Z-56
(2017)

**WIGLEY RD. TRACT
RESIDENTIAL COMMUNITY
ZONING PLAN**

PETITION NO: Z-56

ZONING COMMENTS:

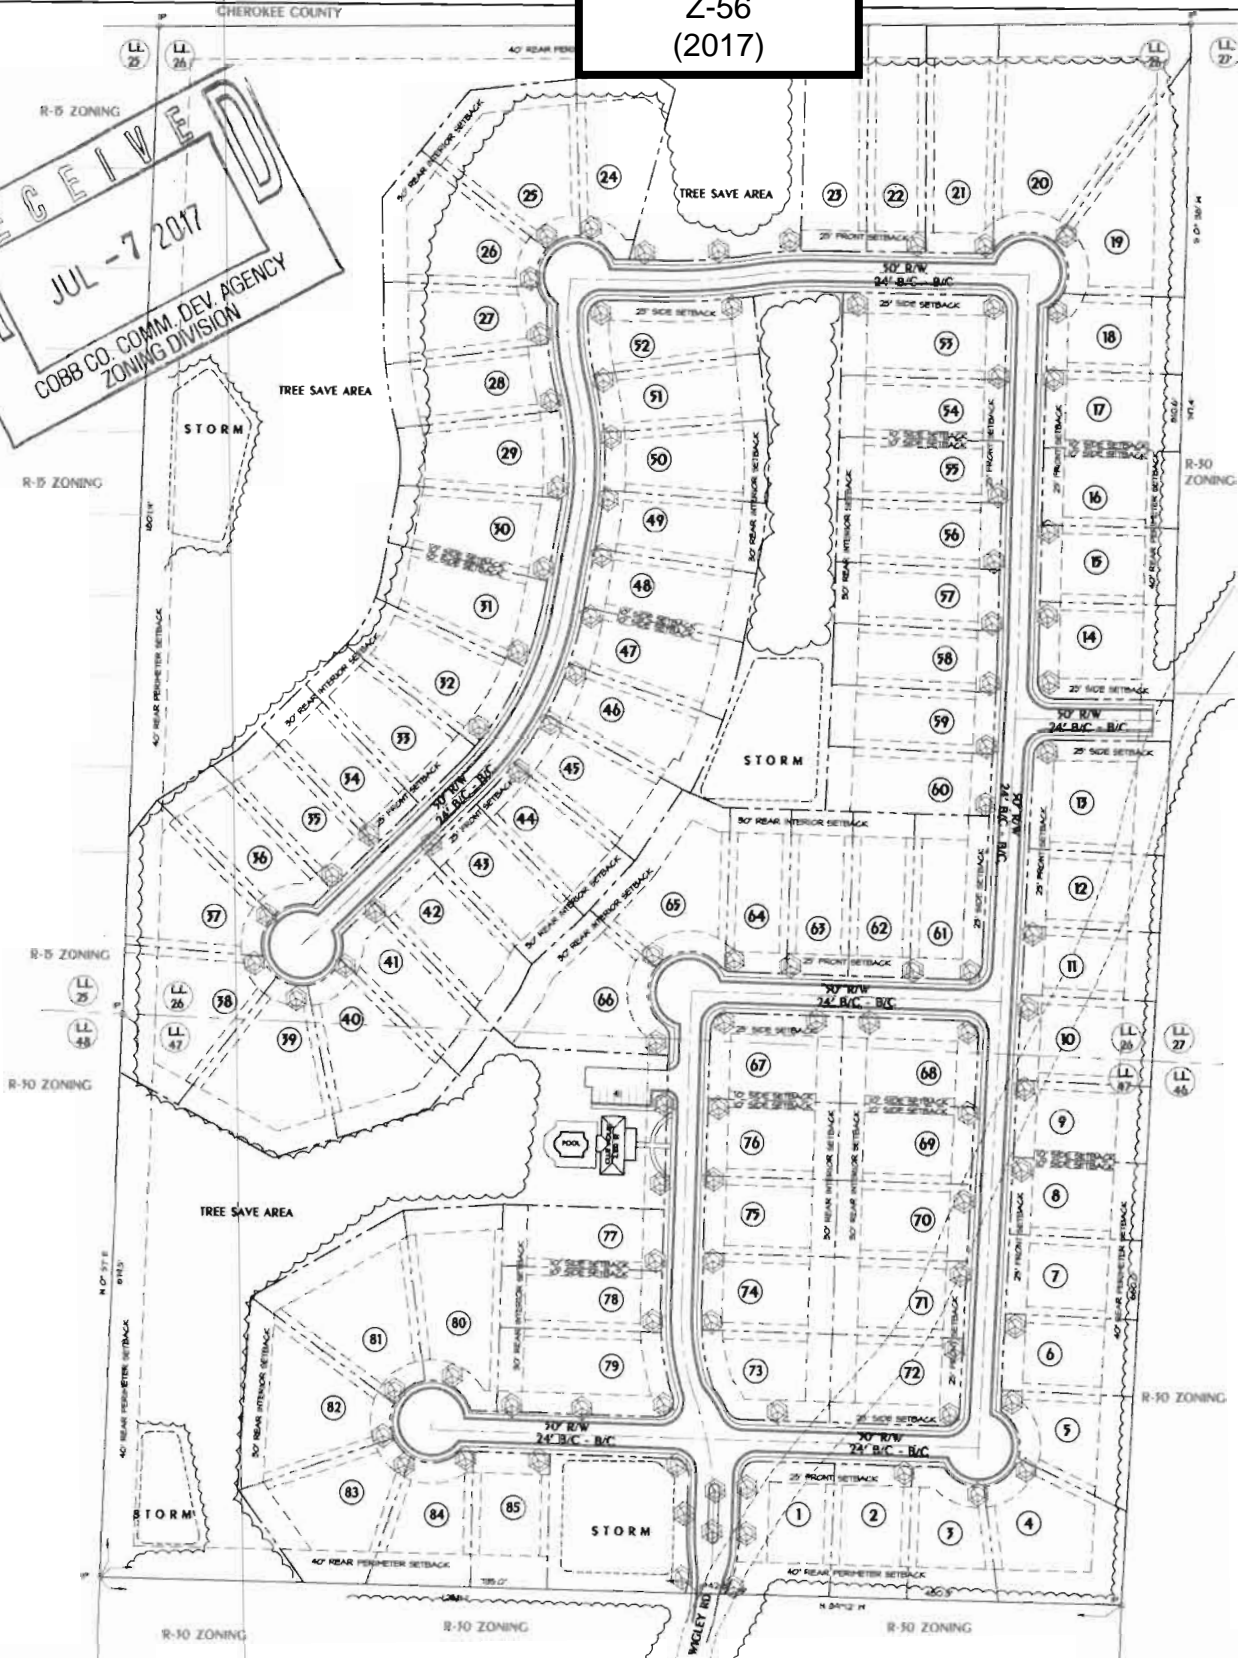
1. Waive the front setback on all lots from the required 35 feet to 25 feet; and
2. Waive the public road frontage on cul-de-sac lots from 50 feet to 38 feet.

1. This site is located on the northern portion of Wigley Road. The site lies on a steep ridgeline and drains in three directions. The majority of the site (40%) drains to the south roughly parallel to Wigley Road. Approximately 35% of the site drains to the northeast along Wigley Road into Cherokee County. The remaining 25% of the site drains to the west into and through the adjacent Falcon Crest Subdivision. The site is predominately wooded with steep slopes ranging from 12 to 40%. The site layout needs to be sensitive to the steep topography. A preliminary rough grading plan should be provided to verify feasibility of the proposed layout.

2. Stormwater management for the site will be provided by multiple onsite detention ponds. The pond locations may need to be adjusted to limit grading required and to adequately control runoff from the development.

4. A downstream headwater pool analysis will be required for the existing receiving culvert in Falcon Crest S/D to verify no adverse impact. The basement at 2254 Hawk Trace is located significantly below the low point of the road.

Wigley Drive is classified as a local and according to the available information the existing right-of-way does not meet the minimum requirements for this classification.

The existing Wigley Road right-of-way will need to be abandoned prior to Land Disturbance Permit.

- A. It is Staff's opinion that the applicant's rezoning proposal may not permit a use that is suitable in view of the use and development of adjacent and nearby properties. Almost all of the properties on this part of Wigley Road are zoned R-30 (only a portion of this part of Wigley Road is not zoned R-30). R-30 OSC would be a better choice due to the slopes.

- B. It is Staff's opinion that the applicant's rezoning proposal may have an adverse effect on the usability of adjacent or nearby property. The property is severely impacted by steep slopes and staff is concerned about erosion issues downstream and downslope. Other developments, zonings and densities in the area include: Jefferson Township Phase Five (zoned PD at approximately 0.32 units per acre); The Summit at Sweat Mountain (zoned R-30 at 0.72 units per acre); Bluffs at Jamerson (zoned R-20 at approximately 1.60 units per acre overall for Phases 1 and 2); Hampton Ridge Unit IV (zoned R-15 at 1.65 units per acre); and Falcon Crest Subdivision Unit III (zoned R-15 at approximately 2.50 units per acre).

- E. It is Staff's opinion that there are existing and changing conditions affecting the use and development of the property which give supporting grounds for denying the applicant's rezoning proposal. The surrounding area of Wigley Road is zoned as R-30. The steep slopes on the property, if developed in a more intense manner, can impact surrounding and downstream properties. Larger lot R-30 development would be preferable due to less grading activity. Staff is aware that other neighborhoods in this area have caused drainage and sedimentation problems due to smaller lot sizes on steep slopes. Staff would be amenable to an R-30 OSC plan due the steep slopes and adjacent zoning districts.
